April 27, 2015
NRC-15-0044

- Subject: Response to NRC Request for Additional Information for the
Review of the Fermi 2 License Renewal Application – Sets 27, 28, 29, and 31

**Fermi 2 NRC Docket No. 50-341
Operating License No. NPF-43**

**DTE Response to NRC Request for Additional Information for the
Review of the Fermi 2 License Renewal Application – Sets 27, 28, 29, and 31**

Figure 1: Bolts shown in new condition indicating exposed threads

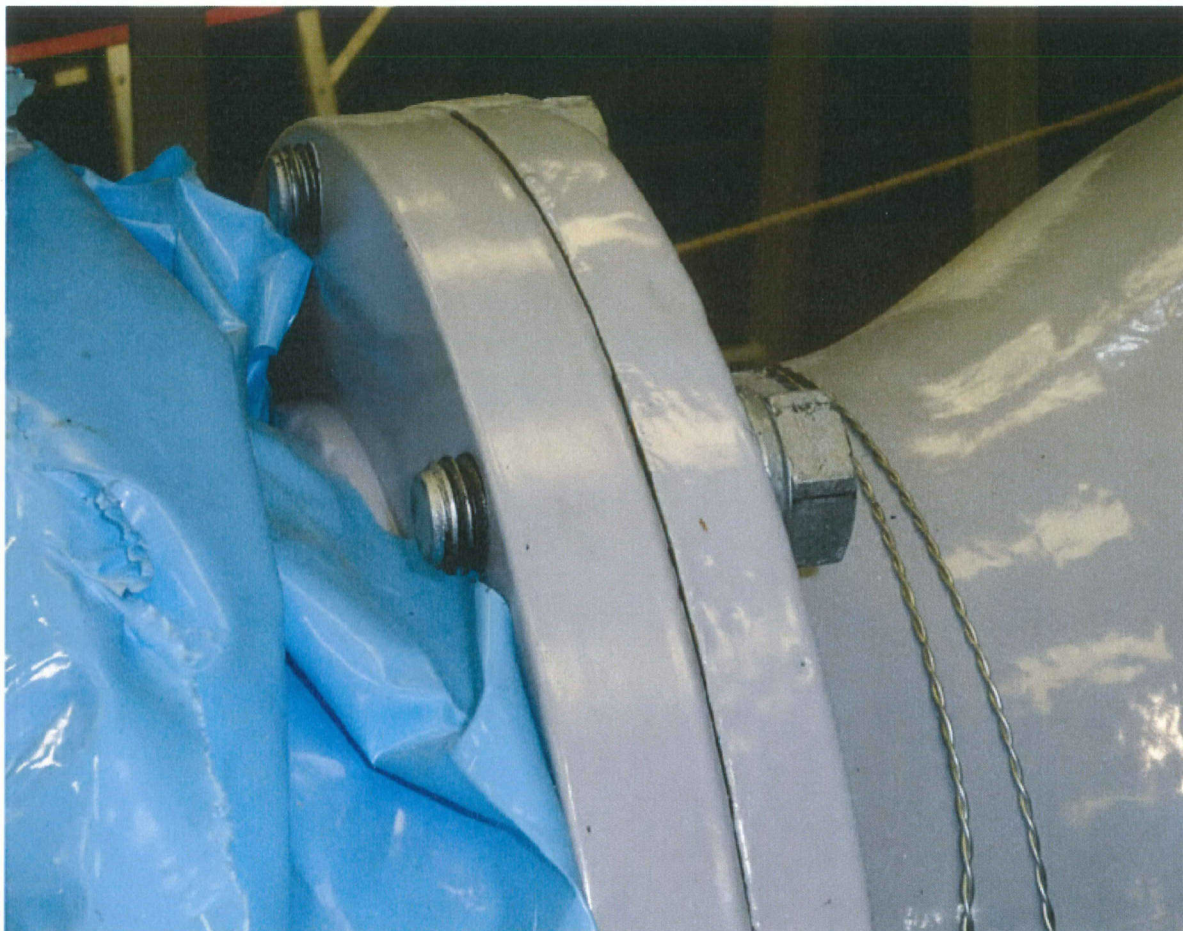
1. *Provide the number of times (including year) that maintenance activities (e.g., pump repair or refurbishment) have been performed for the RHRSW, EESW, and EDGSW systems with submerged bolting.*
2. *Provide the technical basis as to how the proposed inspections will ensure that the aging effects for the threaded area of the submerged bolting will be timely detected and adequately managed before there is a loss of intended function.*

The periodic inspections of the submerged bolting that are currently performed, and will be performed every refueling outage during the period of extended operation, are capable of visually inspecting both bolt heads and some bolt threads in most configurations. Figure 1 on the following pages show an example of a bolting configuration prior to use. The figure shows that portions of the bolt threads protrude beyond the flange and will therefore be

visible during the inspection. Plant-specific operating experience has identified degradation in the exposed bolt heads and threads and led to the replacement of bolts under the corrective action program. Visual inspection of the degraded bolts after their removal has indicated that the worst degradation occurs on the bolt head and threads that are exposed. Photographs verifying these results are shown in Figures 2 and 3 on the following pages. As a result, the exposed bolt head and threads that are visually inspected on a periodic basis provide the leading indication of degradation and bound the condition of the bolt threads in the non-exposed, load-bearing portion of the bolts (i.e. inside the flange). For this reason, aging effects in the threaded area of the submerged bolting will be detected in a timely manner and adequately managed prior to loss of intended function. When degradation of the exposed bolting is discovered during periodic inspections, the bolting will be replaced in accordance with the corrective action program, similar to what has been done previously as described in the response to request 1 above. Each bolt replacement represents an additional opportunity to confirm the plant-specific operating experience that the exposed region of the bolt threads is the leading indication of degradation and bounds the condition of the non-exposed region.
